YARRA CITY COUNCIL
Internal Development Approvals Committee
Agenda – Late Item
Part 2 (Item 1.2)

-
- 1.2 PLN19/0570 - 81 – 89 Rupert Street, Collingwood. - Construction of mixed use (up to thirteen storeys - containing a residential hotel, retail (shops), cinema, restaurants, restricted recreation facilities – permit required uses) building (inclusive of mezzanine levels) and a reduction in the car parking requirement.**
-

1. This report provides Council with an assessment of planning permit application No. PLN19/0570 which affects land at 81 – 89 Rupert Street, Collingwood.

Figure 22: Demolition plan of the former Davis’ Pickle and Sauce Factory building’s façade as prepared by 6a Architects, dated 22 May 2020.

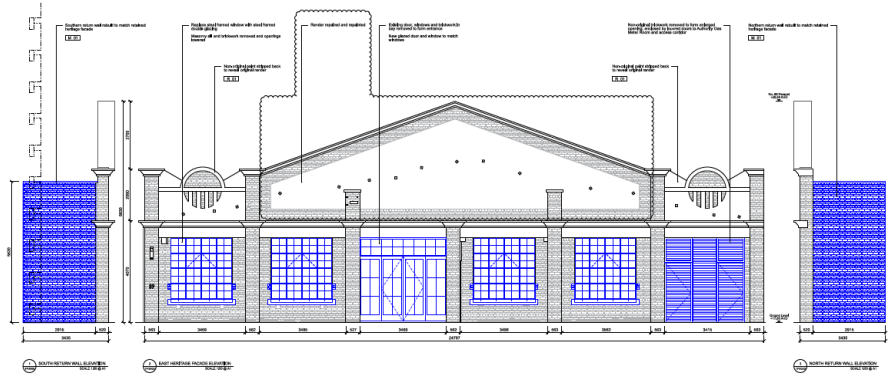
180. The structure of the heritage comment as they relate to demolition concentrated on the demolition of heritage feature including dropping of the sill heights of the windows, demolition of the return walls of the retained heritage building and the removal of the parapet render. Comments regarding the materiality of the building will be responded to later in the report.

183. The widening of the central opening to the “Former Davis’ Pickle and Sauce Factory building” façade, is supported, given that this relates to a smaller portion of wall and a smaller window as compared to the remainder. This is considered to be a good compromise in terms of achieving a response that maintains the integrity of the building whilst adapting this to the development.

182. The revised architectural plans as prepared by 6a Architects, dated 22 May 2020, have also included plans to scale of 1:50 of the façade showing the extent of restoration and renewal with regard to the return walls, with annotated dimensions of wall thickness and façade height. The replacement return walls are supported and a condition will require the decision plans to include this detail whilst maintaining the existing windows.

Figure 23: Undercroft to Building B.

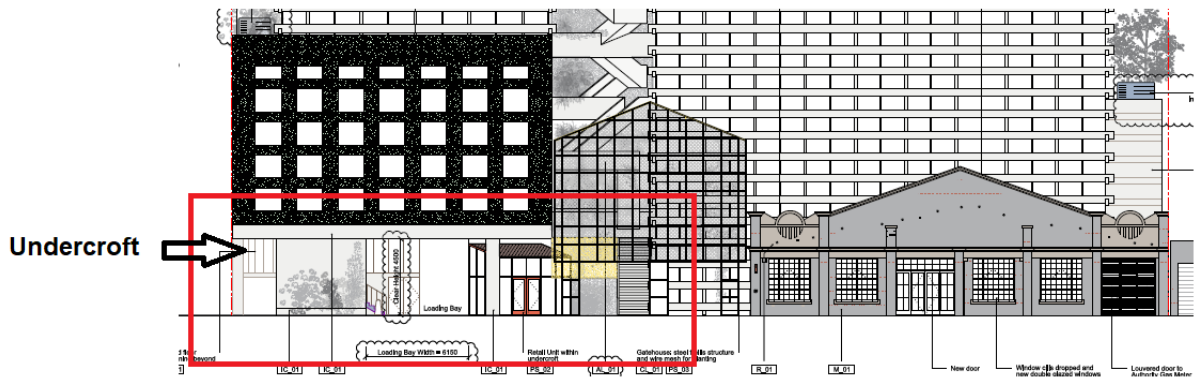
194. The ground level of Building B proposed an undercroft arrangement with a recessed retail premises and the sideage of the proposed substation and vast entry space leading to the core of the building and lobby space of the building.

195. The urban design comments regarding this ground level interface were critical of the lack of integration and legibility of the space and recommended more activation at ground level. The permit applicant showed in the schematic plans, dated 22 May 2020, a redesigned ground level which improved the street interface by relocating the retail tenancy (i.e. “Unit A”) to Rupert Street and relocating the substation further west, addressing the comments made by Council’s Urban Design consultant in relation to increasing the extent of active frontage. Additionally the revisions included substantial columns which better reflect the hard edge construction typically found in the area while still maintaining a good level of permeability into the site (See figure below).

Figure 27: West elevation identifying the ribbed interface of Building B.

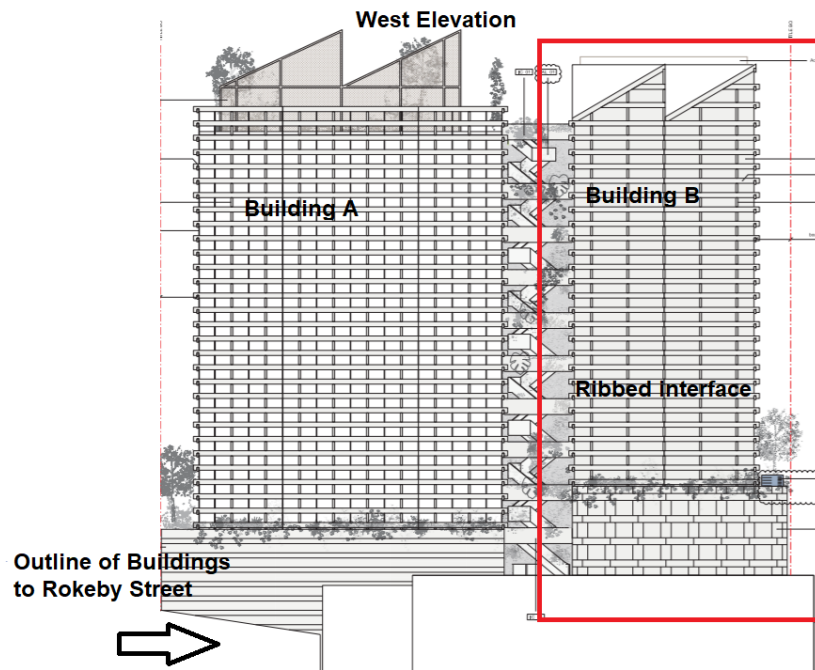
203. Council’s Urban Design consultant has indicated support of the narrow setbacks adopted at the fifth through to the twelfth levels of Building B as measured from the western boundary. This elevation has façade ribs extending into this setback and importantly no windows (see Figure 24 below) located to this interface which does not raise issues of any future implied rights to light. Where located, this stretch of built form abuts the western property site namely property no. 110 Rokeby Street. Council’s Urban Design consultant has expressed support for this configuration, stating that future development to the west (and hence associated equitable development opportunities) will be able to adopt a zero setback, whilst in the meantime the current scheme does not result in an unarticulated blank wall facing west.

205. Council's Urban Design consultant recommended the further articulation of the towers so that these interfaces become less imposing to the street, but didn't provide any re-design suggestions. However, it is considered that the varied ribbed approach to each building, combined with the transitioning podium at the street level, and solid to void ratio, all stack up to provide a well-articulated building when viewed as a whole, both from close range angles and long range. It is agreed with the permit applicant's response to the referral advice of 3rd June, that *"the façade mediates this scale – of close and near – with the use of many small components that are assembled or 'stacked' together to form a façade that has a very deep articulation (more than half a metre in relief) that allows the building to read as a clear volume from afar but increases the visual texture and detail as one sees the building closer or interacts from inside the building"*.
